FAWN LAKE DAM

PHASE I INSPECTION REPORT
NATIONAL DAM INSPECTION PROGRAM

NDI PA 00309
PA DER 52-168

FEBRUARY 1979

FAWN LAKE DAM
General Plan of Features
with Inspection Notes

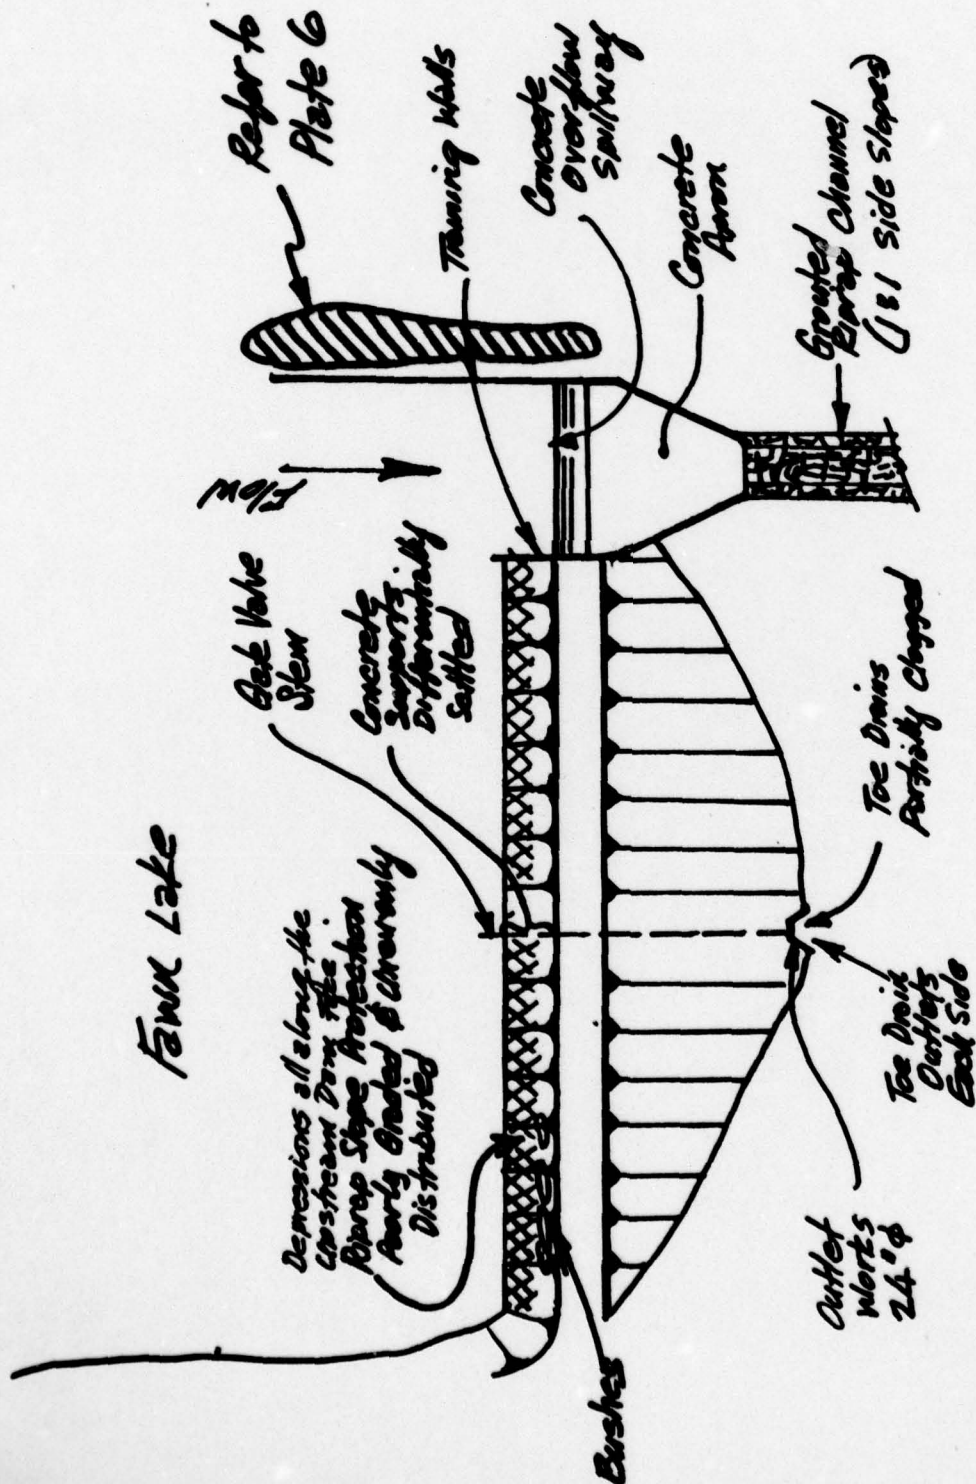
b. Dam. The riprap on the upstream face of the embankment is a poorly graded mix of large, relatively flat, angular rocks and smaller stone. There is little uniformity in the distribution and placement of the rock. Small bushes and animal burrow holes are located at several points along the upstream face.

An undulating depression was observed along the upstream face of the dam, about 1 to 3 feet from the top of dam. The depression extends across much of the embankment parallel to the crest. The depression varies in depth from a few inches to more than 2 feet. Field measurements of the top of dam and both side slopes reveal no inconsistencies with the design drawings.

1) The depressions along the upstream slope and along the left training wall should be monitored to determine if any differential movement occurs.

2) The riprap should be supplemented with large and medium sized rock to provide a well graded riprap layer to extend to the top of dam.

3) Animal burrow holes should be filled with suitable material, and all bushes should be removed from the embankment.

4) Areas below design elevation should have additional fill placed to regrade the embankment to design elevation.
